YANKEE ATOMIC ELECTRIC COMPANY

References: (a) License No. DPR-3 (Docket No. 50-29)
(b) YAEC letter to USNRC dated September 8, 1978
Proposed Change No. 163
(c) NRC letter to YAEC dated November 8, 1978

Subject: Additional Information - Core XIV Refueling

FIGURE 7-1
Core XIV Allowable Peak Rod LHGR
Versus Cycle Burnup

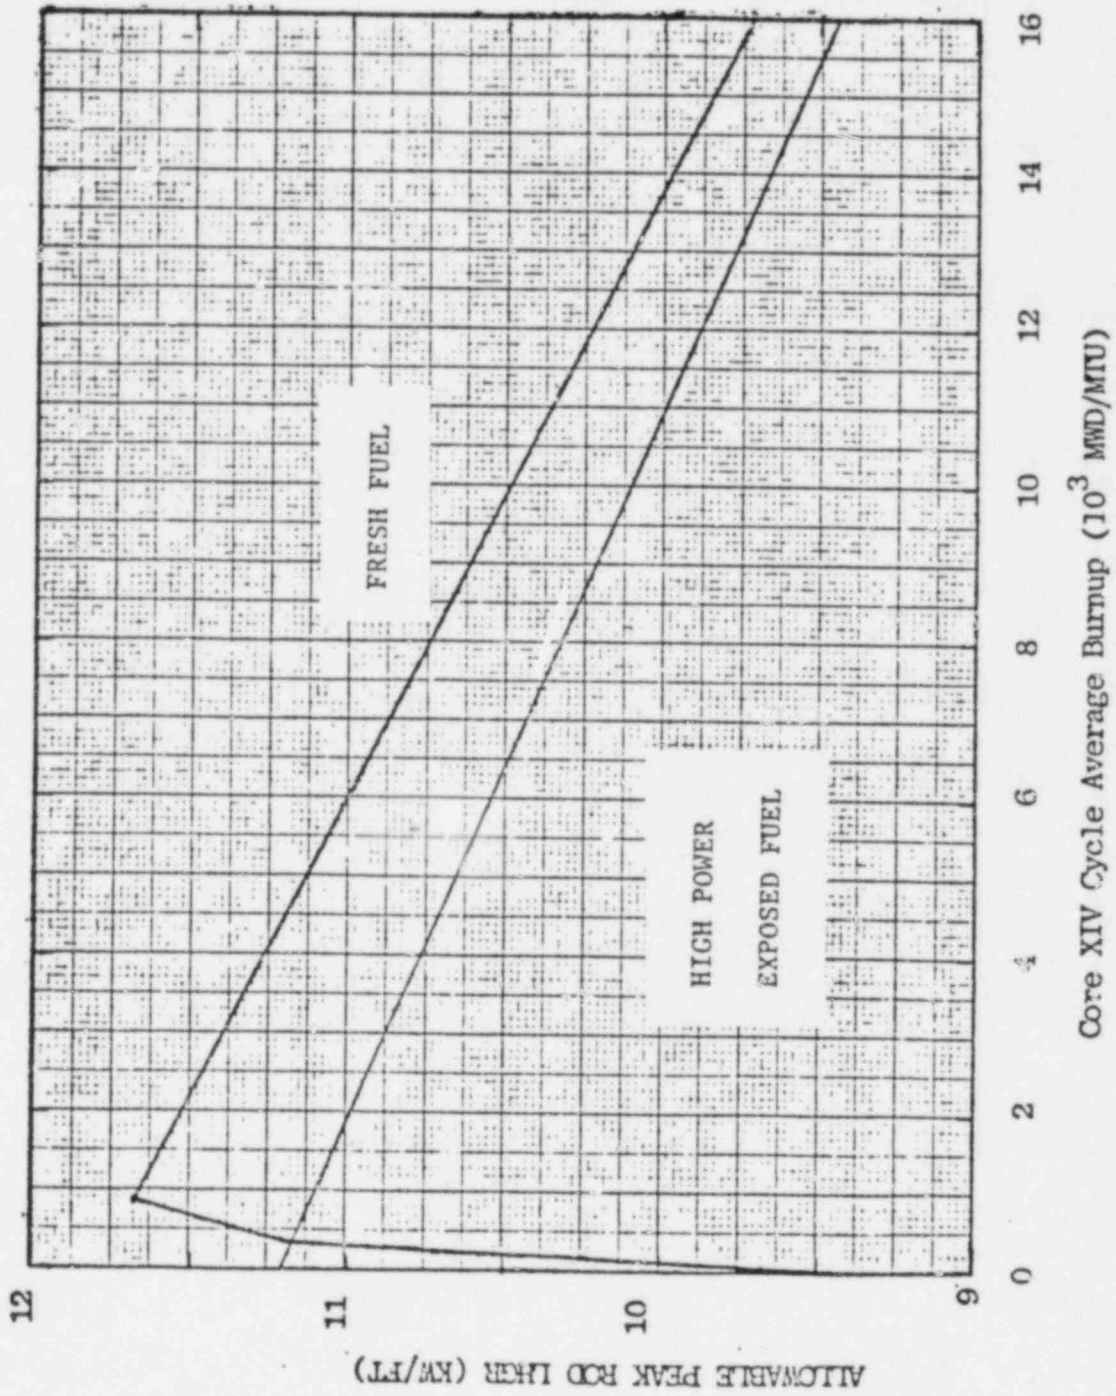
You make the statement that according to the results of your burnup sensitivity studies the most highly exposed recycled fuel rods and the highest powered recycled fuel rods are not limiting when the peak linear heat generation rate of the fresh fuel is maintained at or less than the value given in FIG. 7-1 in the reload submittal. This holds true even though at 16000 MWD/MTU burnup the calculated value of allowable peak linear heat generation rate (APLHGR) for the fresh fuel is higher than the corresponding values for the recycled fuel. Discuss the basis for your statement and provide the supporting evidence.

Based on these statements, plant operation within the limits defined by the LOCA analyses performed for Cycle XIV can be maintained by using two curves of APLHGR versus CABU. The two curves are 1) APLHGR versus CABU for the fresh fuel and 2) APLHGR versus CABU for the high power exposed fuel. The attached Figure 7-1 provides this information.
